# Access Compliance Report

## Public Rights-of-Way

Intersection ID: 12644	Main Street: E_7TH_ST	Cross Street: N_ALEXANDER_ST	Location: E
ADA ID: 813104C85714	Ramp Type: BlendTrans2	Initial Pass/Fail: Fail	Overall Compliance: No
		Severity Score: 10

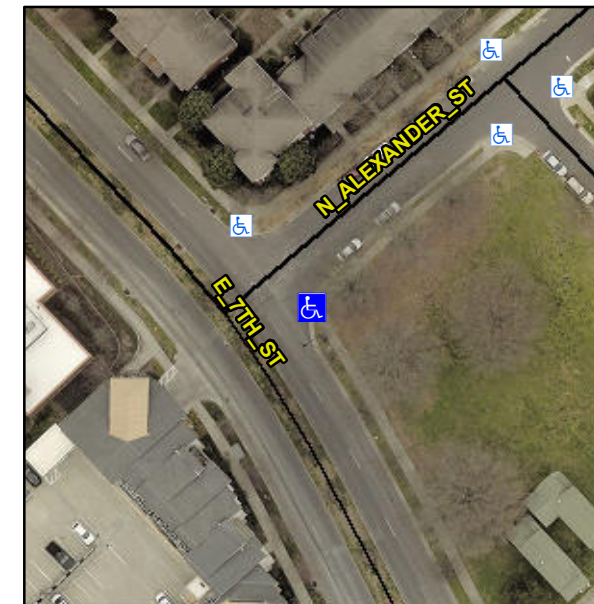
**Not Found, R304.5.1, R304.5.3**

Compliance	Description	Data	Compliance	Description	Data
N/A	Ramp Length (in)	85.0	Yes	BlendTrans Slope (%)	3.0
No	Ramp Width (in)	41.0	No	BlendTrans XSlope (%)	2.1
N/A	Flare Type LT	N/A	N/A	Flare Type RT	N/A
N/A	Flare Slope LT (%)	N/A	N/A	Flare Slope RT (%)	N/A
N/A	Flare Traversable LT?	N/A	N/A	Flare Traversable RT?	N/A
N/A	Landing Length (in)	N/A	N/A	DWS Provided?	N/A
N/A	Landing Width (in)	N/A	N/A	DWS Contrast?	N/A
N/A	Landing Slope (%)	N/A	N/A	DWS Length (in)	N/A
N/A	Landing X Slope (%)	N/A	N/A	DWS Full Width?	N/A
N/A	Landing Curb? (Y/N)	N/A	N/A	DWS Offset (in)	N/A
N/A	Shared Landing?	N/A			
N/A	Gutter Ponding?	N/A	N/A	Gutter Slope (%)	N/A
N/A	Gutter Lip Ht (in)	N/A	N/A	Gutter X Slope (%)	N/A
N/A	Painted X Walk1?	No	N/A	Painted X Walk2?	N/A
	X Walk 1 Direction	To NW		X Walk 2 Direction	N/A
	X Walk 1 Width (in)	N/A		X Walk 2 Width (in)	N/A
	X Walk 1 Slope (%)	0.9		X Walk 2 Slope (%)	N/A
	X Walk 1 X Slope (%)	1.9		X Walk 2 X Slope (%)	N/A

N/A	Ramp inside XWalk1?	N/A	N/A	Ramp inside XWalk2?	N/A
	Road Slope (%)	1.9		Clear Space?	N/A
	Road X Slope (%)	0.9	N/A	Clear Space to XWalk (in)	N/A
N/A	Any Obstructions?	N/A	N/A	Storm Grate/Utility Hazard?	N/A
	Obstruction Type			Storm Grate/Utility Type	
		N/A			N/A
			Yes	Surface Condition? (G/P)	Good
			No	Curb Slope (%)	18.3

**Remove & Replace Curb Ramp With Two New Directional Ramps or Equivalent.**
